PLAN OF PROPOSED IMPROVEMENT

REVISED BY EEA 8/17/2023

CITY PROJECT NO. 14343
CONTRACT NO. 9217

SOUTHERN ADDITION TO BIRCHWOOD POINT - PHASE 6

14343
X-6

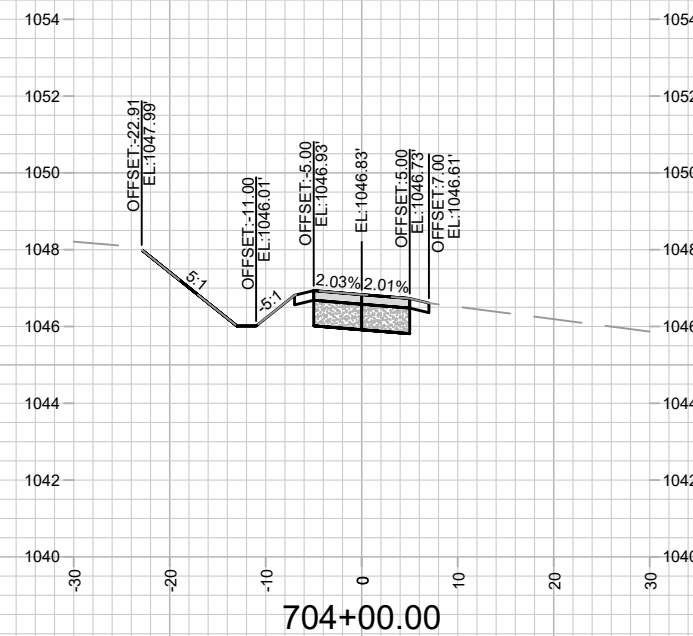
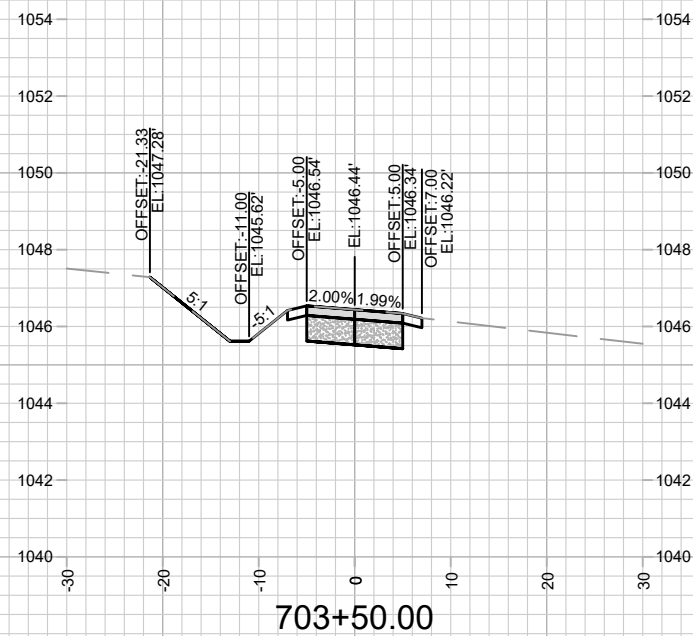
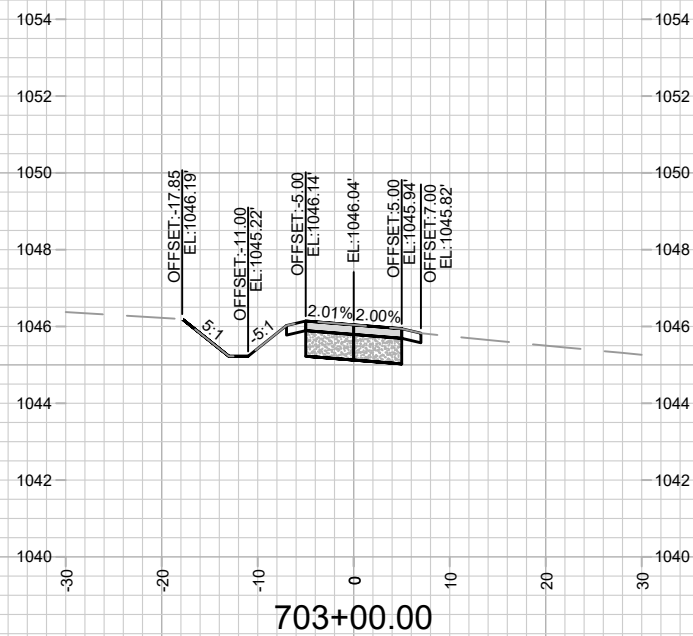
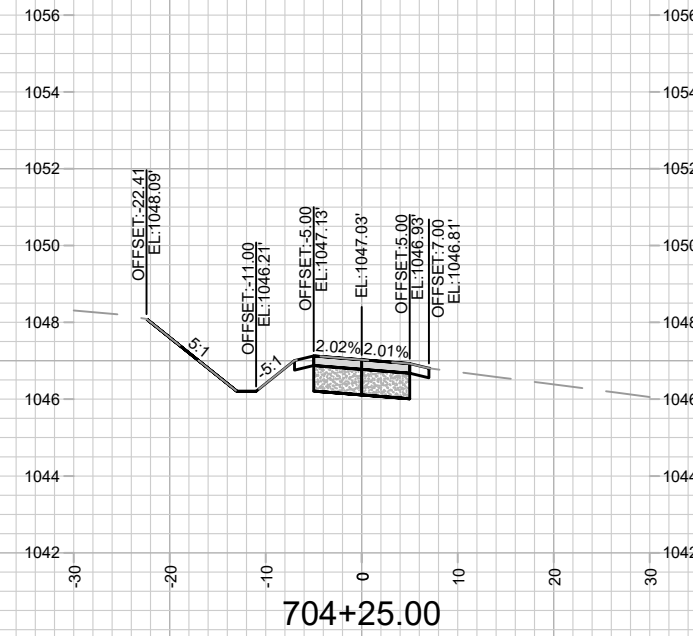
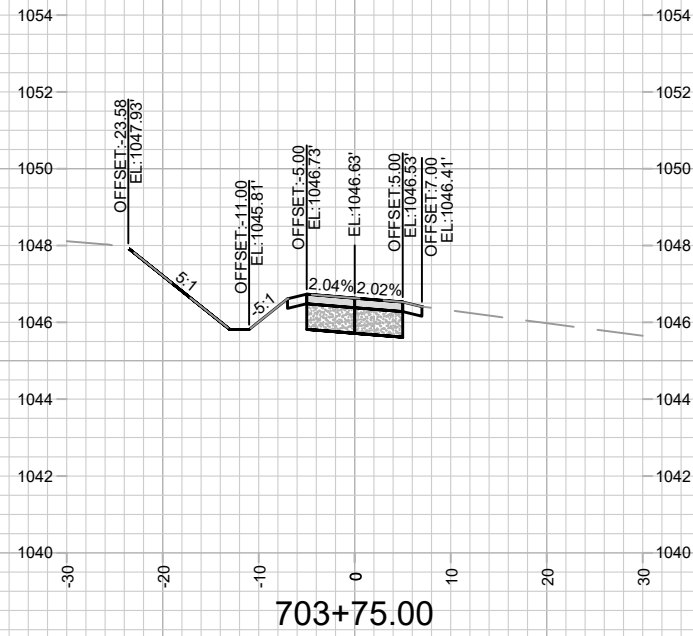
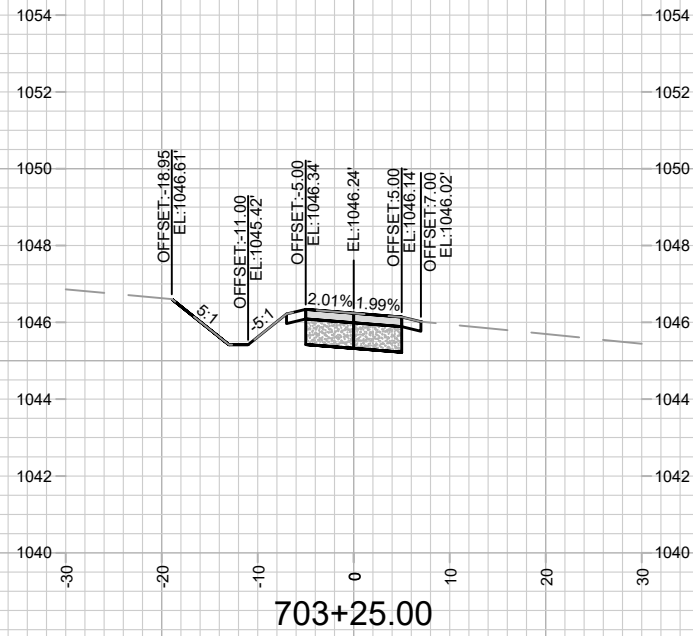
REVISED BY EEA 8/17/2023

1. REMOVED NOTE STATING IMPROVEMENTS WITHIN PARK WERE NOT TO BE BUILT UNTIL REVISION WAS ISSUED
2. UPDATED 10' ASPHALT PATH DITCH AND SLOPE INTERCEPT
3. ADDED EXISTING SURFACE TO CROSS SECTIONS

14343
 X-13

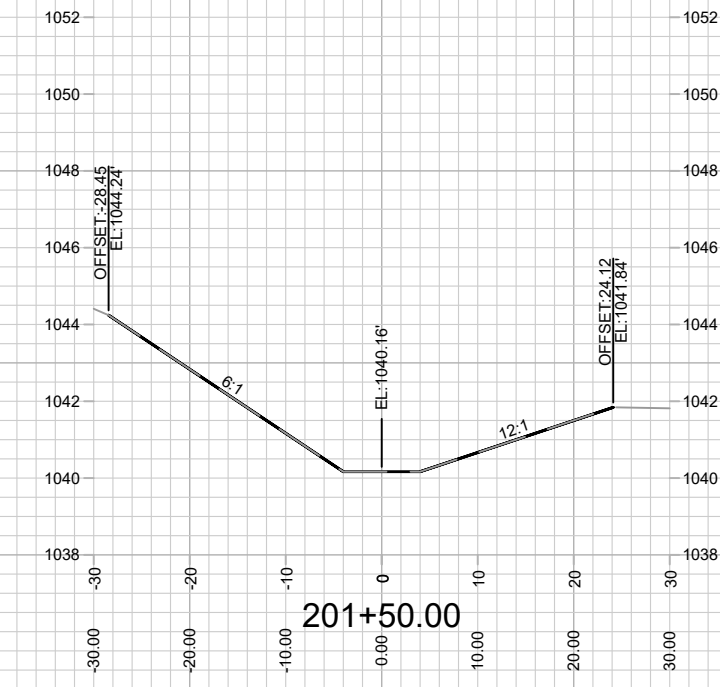
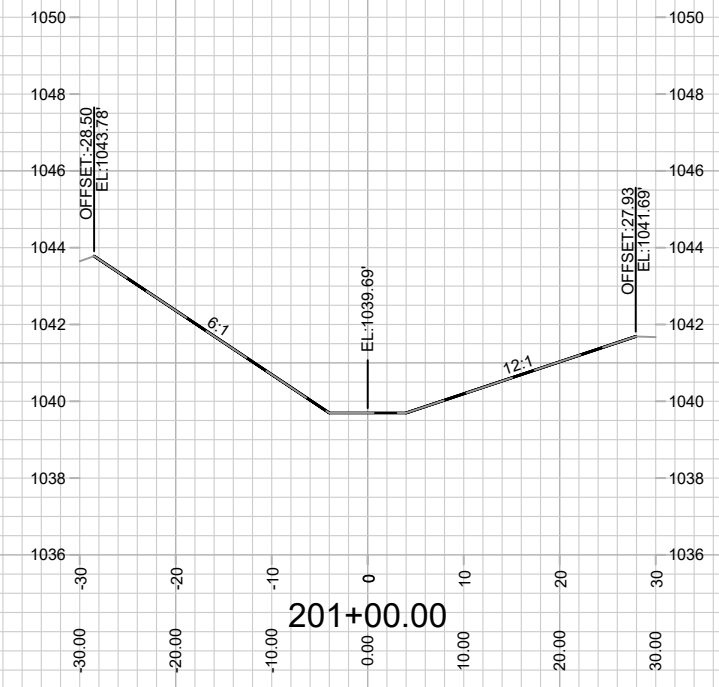
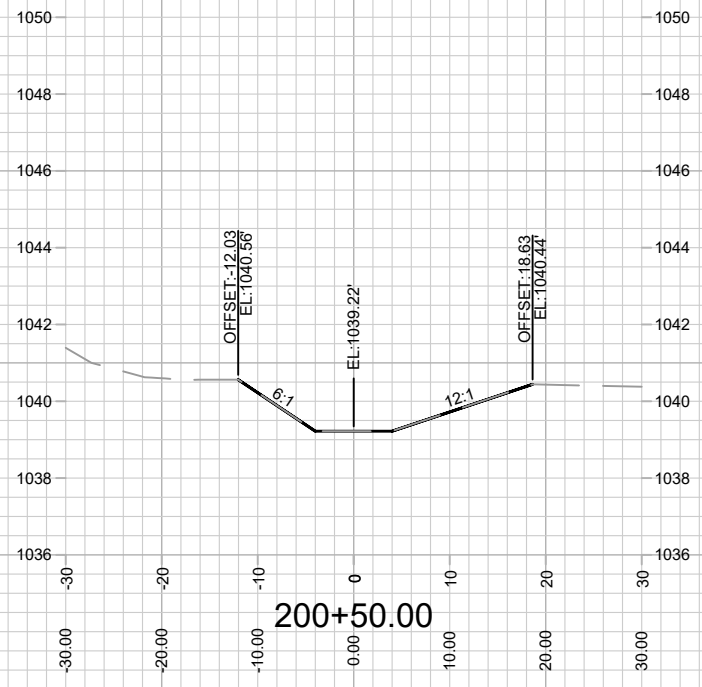
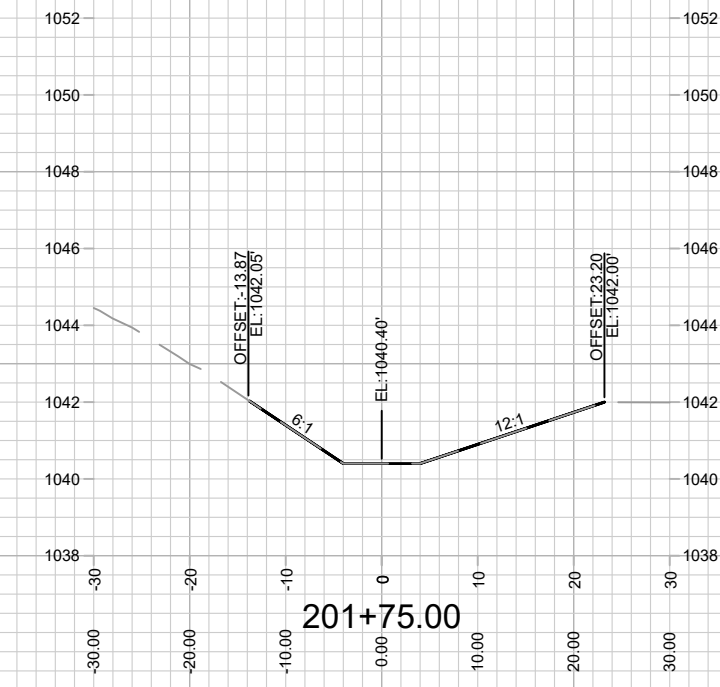
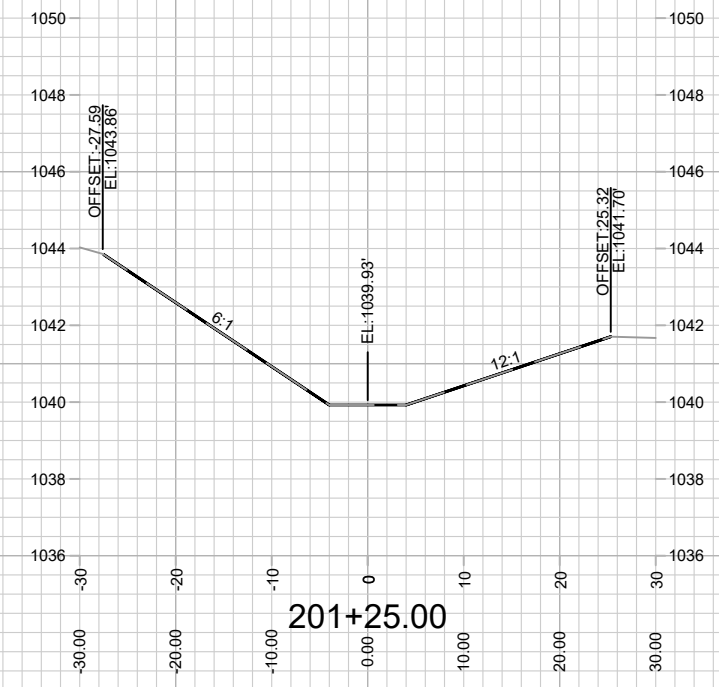
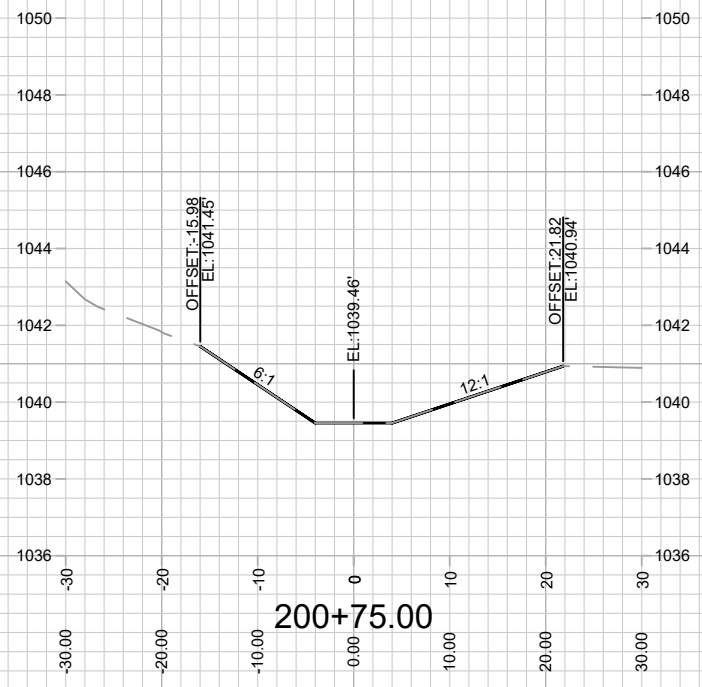
REVISED BY EEA 8/17/2023
 1. REMOVED NOTE STATING IMPROVEMENTS WITHIN PARK WERE NOT TO BE BUILT UNTIL REVISION WAS ISSUED
 2. CHANGED SHEET NAME TO "CROSS SECTIONS - PARK SWALE"
 3. UPDATED PARK SWALE ALIGNMENT AND SLOPE INTERCEPT
 4. REMOVED OUTDATED EXISTING SURFACE

14343
 X-14

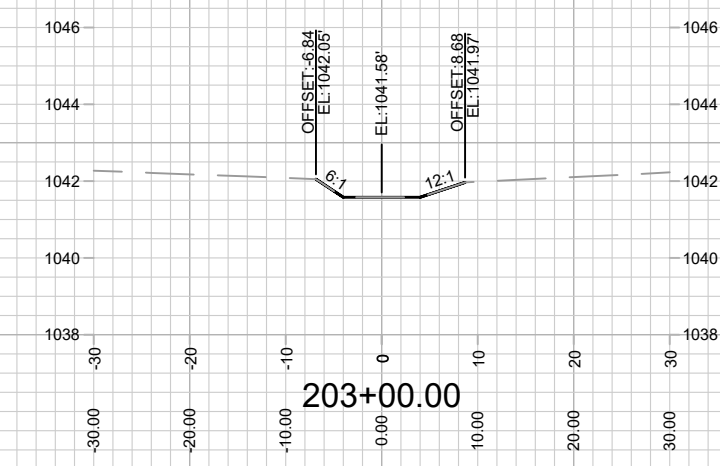
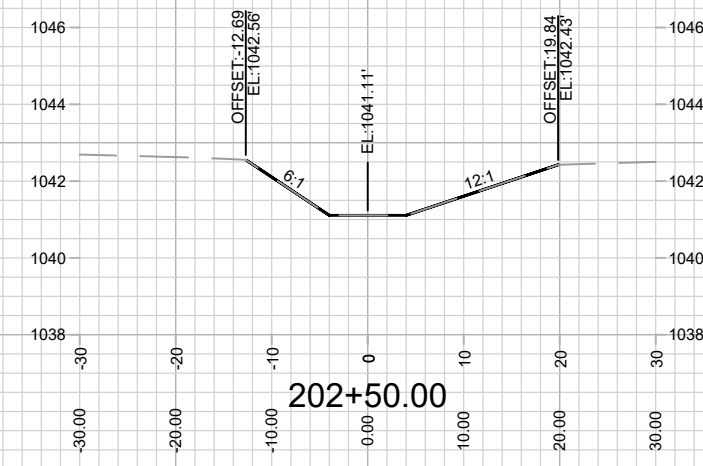
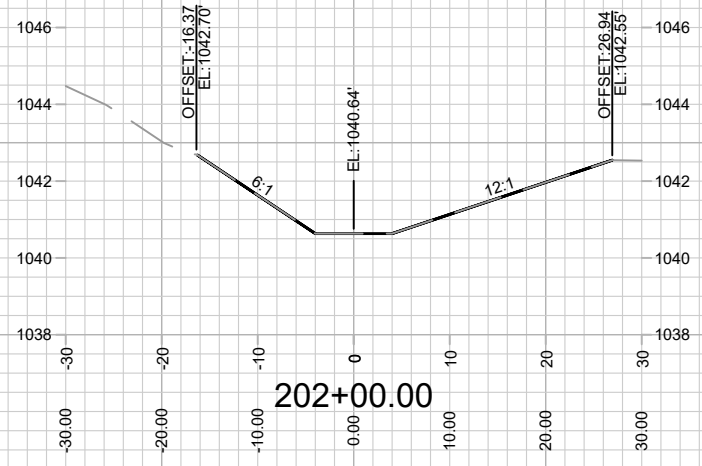
REVISED BY EEA 8/17/2023
 1. REMOVED NOTE STATING IMPROVEMENTS WITHIN PARK WERE NOT TO BE BUILT UNTIL REVISION WAS ISSUED
 2. CHANGED SHEET NAME TO "CROSS SECTIONS - PARK SWALE"
 3. UPDATED PARK SWALE ALIGNMENT AND SLOPE INTERCEPT
 4. REMOVED OUTDATED EXISTING SURFACE

14343
PBM-1

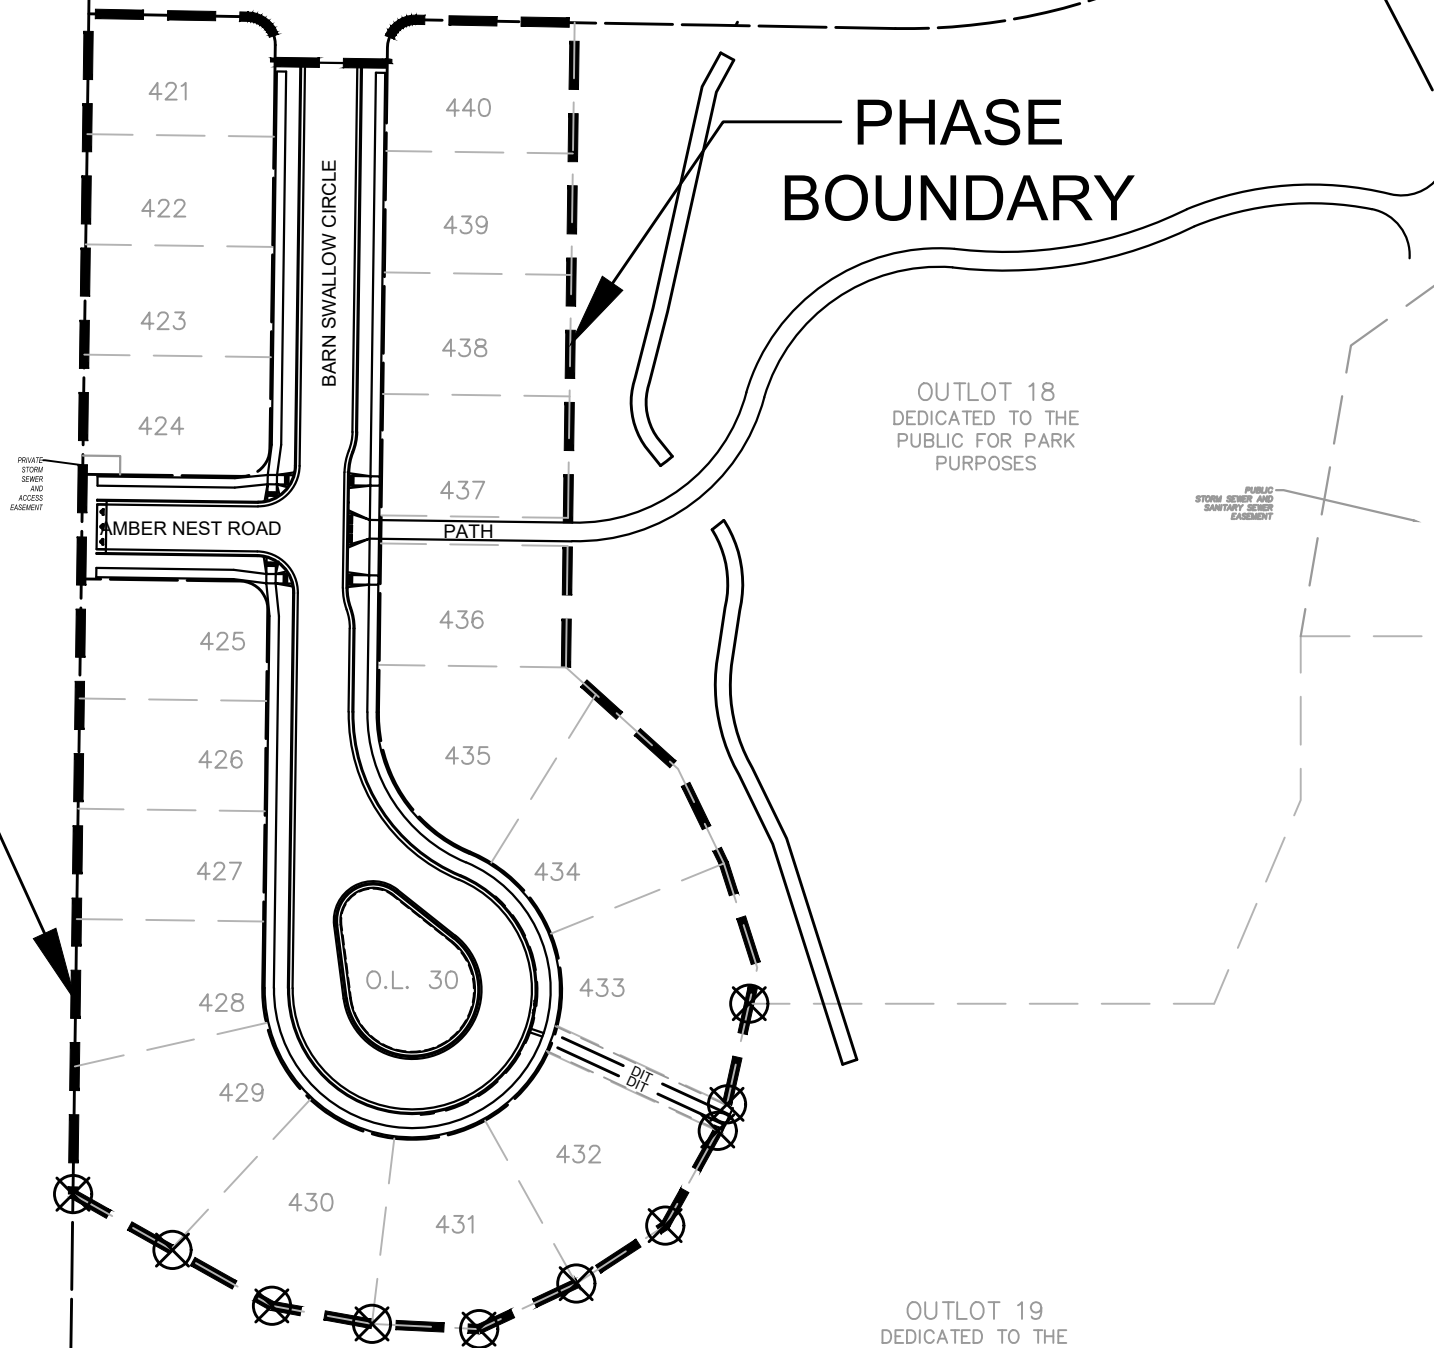
REVISED BY EEA 8/17/2023
1. UPDATED PARK SWALE ALIGNMENT
2. UPDATED ISLAND CURB'S BACK OF CURB LINEWORK TO 1'-10"
